**ADDRESS OF PROPERTY:** 621 East Tremont Avenue, *Dilworth Local Historic District* *HDC 2013-128*

**SUMMARY OF REQUEST:** Second-story Addition

**Details of Proposed Request**

HDC Review Package

PROFILE OF REVISED ELEVATION

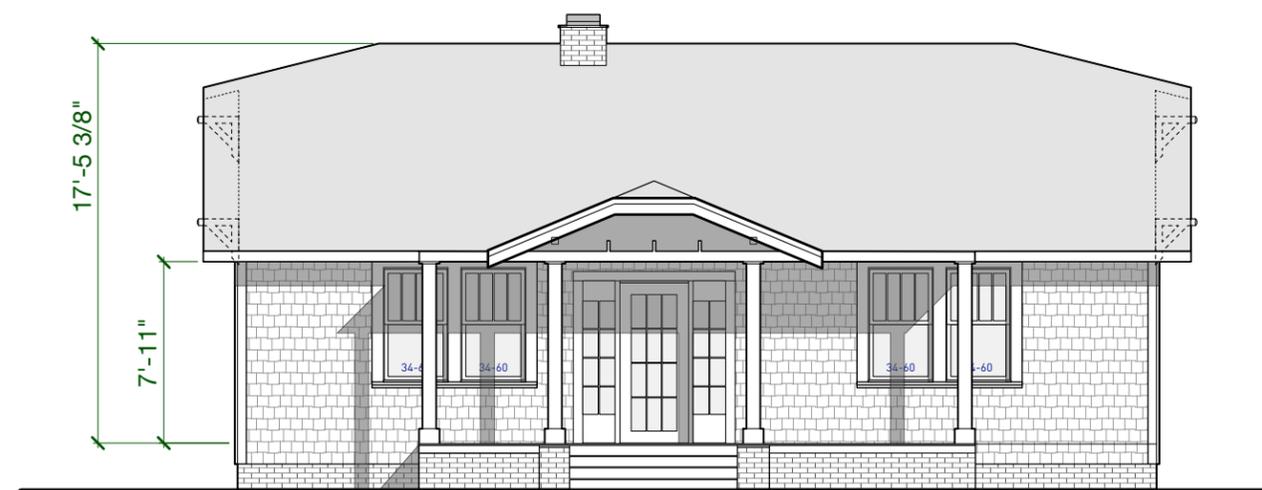
- Reduced pitch of cross gable from 12:12 to 10:12. Lowered cross gable ridgeline 2'-7".
- Reduced pitch of front gable from 16:12 to 13:12. Lowered front gable ridgeline 2'-0".
- Increased size of cross gable clips.
- Removed arched stone portico / door.
- Added clip to front gable.
- Removed curved rafter tail / roof elements.

## Design Progression

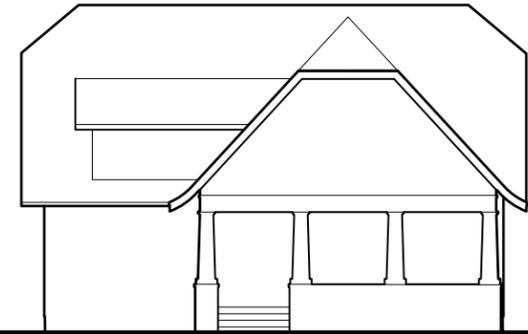
A - May Presentation

B - June Presentation

C - August Presentation

## 2nd Floor Plan

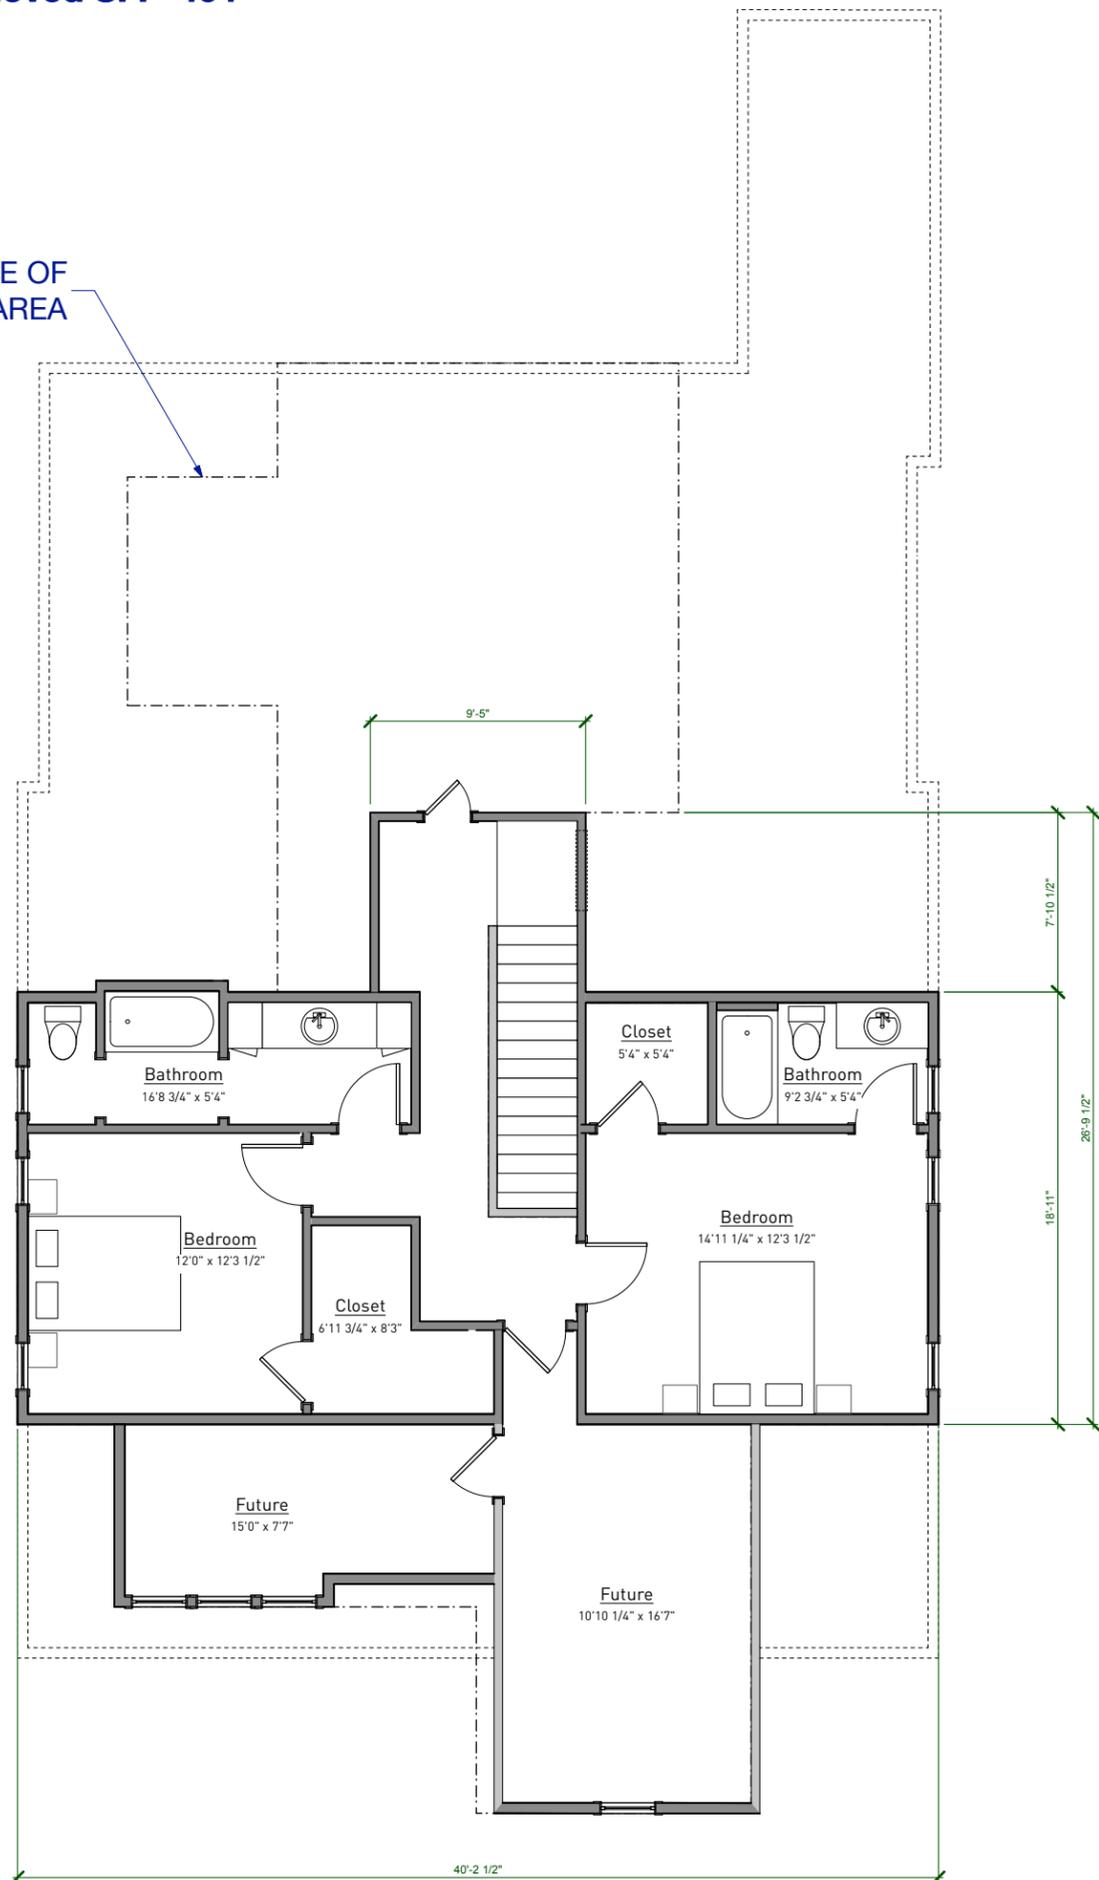
Previous SF: 1,542  
Revised SF: 1,078  
**Total Removed SF: 464**

OUTLINE OF  
REMOVED AREA
